Downtown Code Design Review Committee

Meeting Minutes

May 7, 2020

Figure 2: 13th Ave S Façade

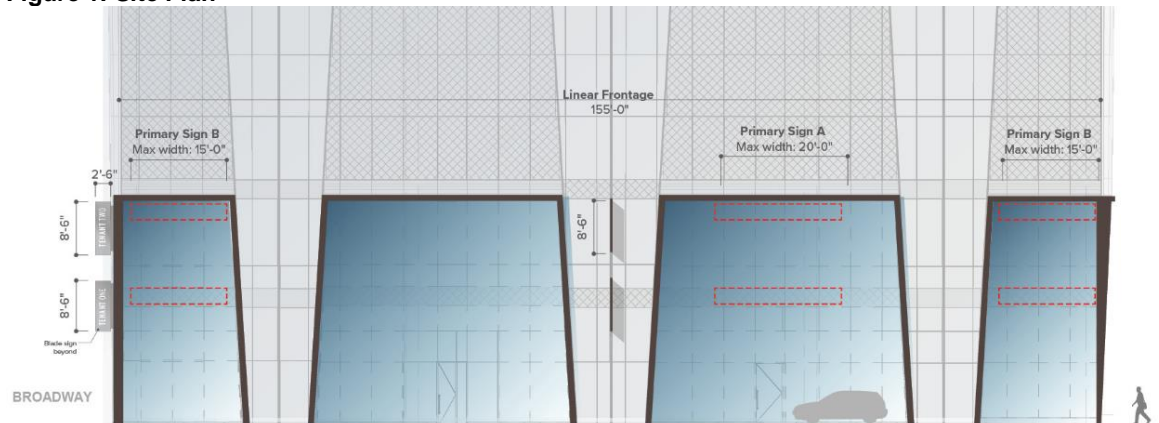
The DTC signage standards classify Broadway as a Gateway street and 13th Avenue as Interstate frontage. Interstate frontages are allowed 1 square foot of signage area per 1 linear foot of street frontage. The modification requests 2 square foot of signage area per 1 linear foot of street frontage, which is the same entitlement allowed both along Broadway and vast majority of streets within the DTC.

The Downtown Code establishes Interstate frontage not just along streets but also along properties where the rear property line abuts the interstate. Interstate frontage standards are meant to control signage on frontages that are highly visible from the interstate but either do not abut streets or are along 13th Ave S / George L. Davis Blvd, which functions somewhat like a frontage road for the interstate between Demonbreun St and Jo Johnston Ave. Frontage along 13th Avenue was not conceived of as developing into a robust active pedestrian frontage.

This project is being constructed as a 24-story building with an active pedestrian frontage on both facades. The ground floor features retail and a mezzanine space, which can essentially support double the retail/restaurant activity of a typical activated frontage. Due to the robust nature of the active uses that are accessed from 13th Avenue S, Planning sees merit in this modification. However, this is due to the number of tenant spaces, as shown on the application. If tenant spaces are combined between the upper and lower floors, Planning would view this modification request differently.

1. If the tenant spaces on the upper and lower stories are combined, the signage modifications are not applicable for that portion of the frontage.

Figure 4: Signage Frontages

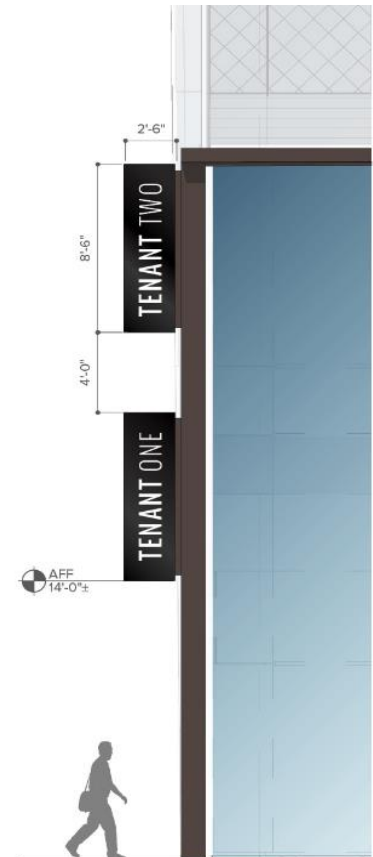
The DTC signage standards require that projecting signs must be located at least 25' from another projecting sign. In this case, proposed signage is located within 4' of another projecting sign. As shown in the figure to the right. The intent of this standard is to decrease visual clutter by avoiding large numbers of these signs.

However, rather than being horizontally adjacent to one another the proposed projecting signs are vertically adjacent with one above the other, just as the tenant spaces proposed are vertically adjacent to one another. If these signs were to be combined, they would not exceed the signage maximums for a single projecting sign. The locations shown do not increase visual clutter.

Landscape Plan at Lower Church

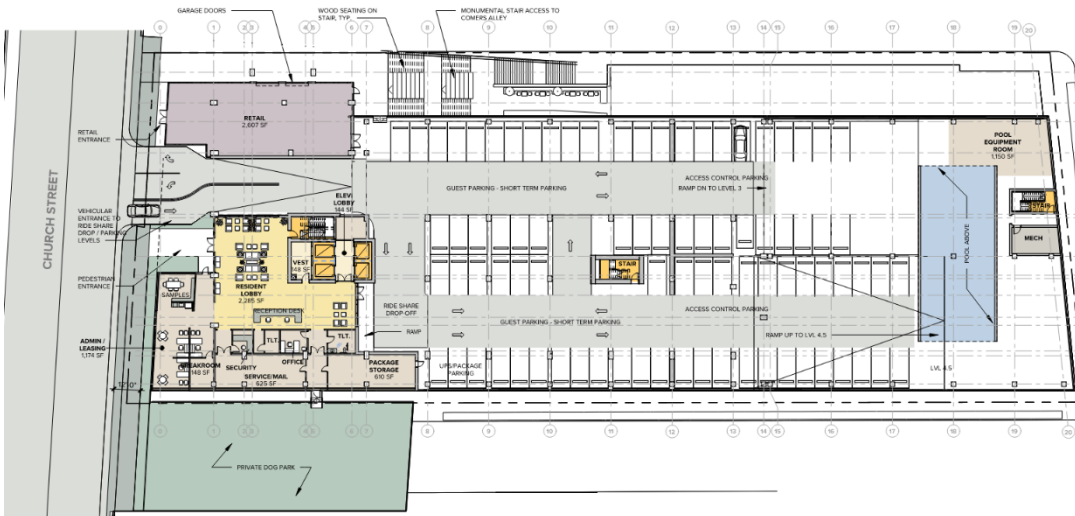
As part of the MCSP, the DTC requires a 4'-0" planting strip on secondary streets. The requested modification is to exclude these planting strips along 12th Ave North and Lower Church Street where elevated structures above the right-of-way preclude adequate sunlight for planting.

1: North Elevation – Church St

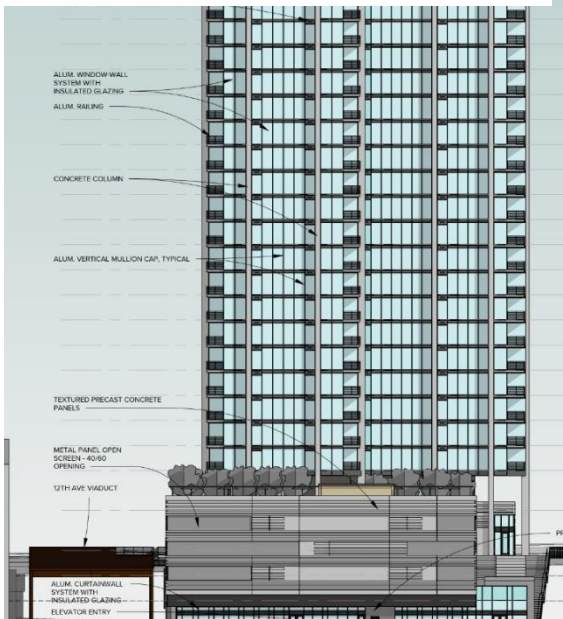
The DTC requires buildings seven stories or greater to step back fifteen feet between the fourth and seventh stories. The requested modification is to permit a step back at the second story on Church St. Due to the topographical change on the site, this would allow the podium to step back at the same elevation as 12th Ave North, the sixth floor on that frontage.

This modification presents an appropriate solution to the challenge of encouraging a pleasant pedestrian experience while negotiating the changes in elevation among the five street frontages.
